Z-34
(2017)

ZONING PLAN
FOR
BURNS LANE PROPERTY
COBB COUNTY, GEORGIA
LAND LOTS 226 & 250 - 19TH DISTRICT

PETITION NO: Z-34

ZONING COMMENTS:

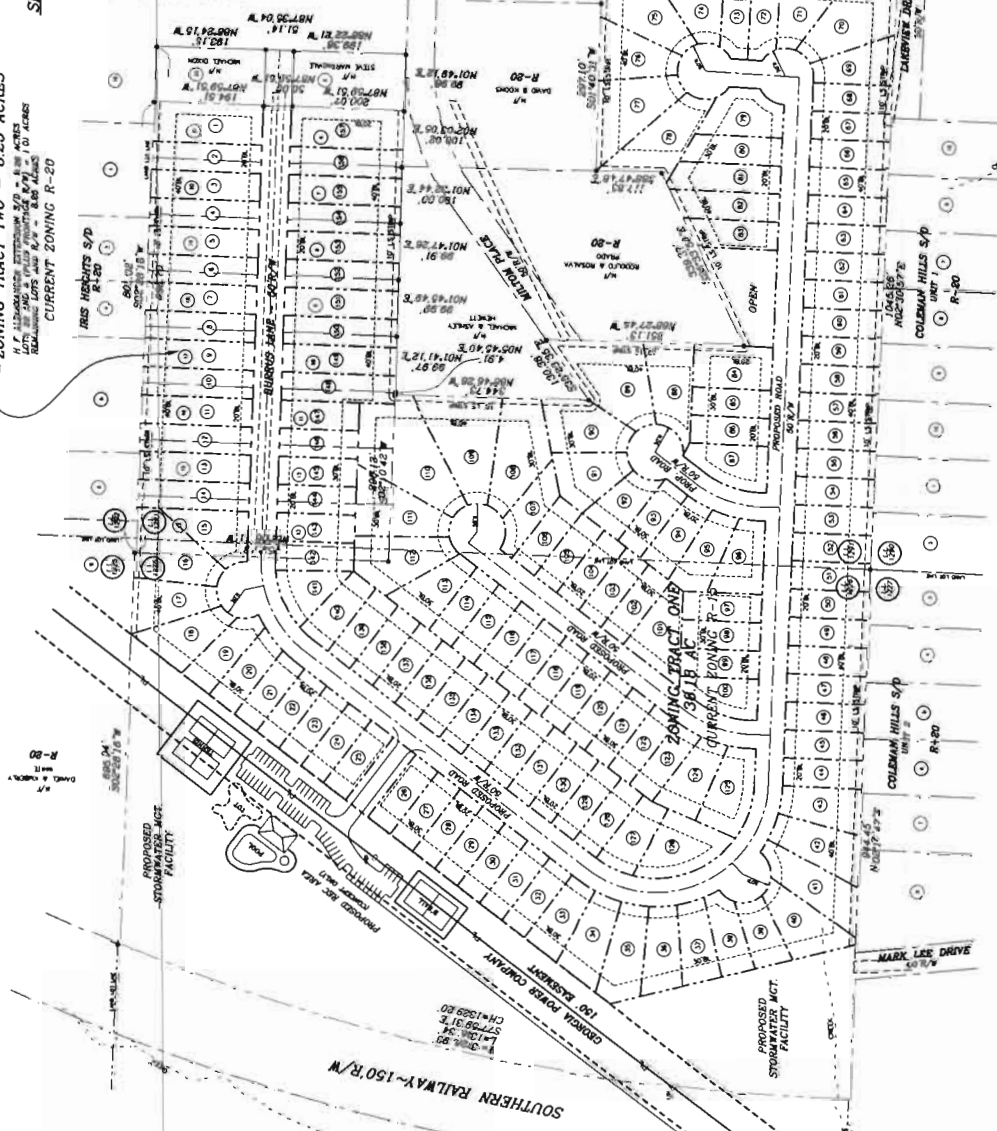
1. This site is located at the northern terminus of Milton Place and Burriss Lane. The site is predominately undeveloped and wooded with moderate slopes averaging from 5 to 15%. A portion of the site was previously developed as the Alexander Subdivision. There is an existing detention pond that was constructed for this development just north of the Georgia Power Line easement near the northeast corner of the site.

2. Stormwater management will be provided by the existing detention pond will be modified to accommodate the runoff from the proposed site, as well as an additional new pond at the northwest corner of the site.

3. Runoff from the upstream adjacent Iris Heights Subdivision to the east must be accommodated through the site. A drainage easement along the rear of lots 1 – 17 will likely be required.

4. Approximately 11.7 acres of the site currently drains into and through the Coleman Hills Subdivision to the west. This is an older subdivision that lacks adequate stormwater infrastructure to accommodate any increase in runoff volume. The applicant has agreed to significantly reduce the runoff discharged to #5489 Janet Lane and to convey all impervious runoff away from #5393 Janet Lane. This will likely require a drainage easement along the rear of lots 40 – 70.

Recommend curb and gutter along both sides and sidewalk along one side of proposed development roadway.
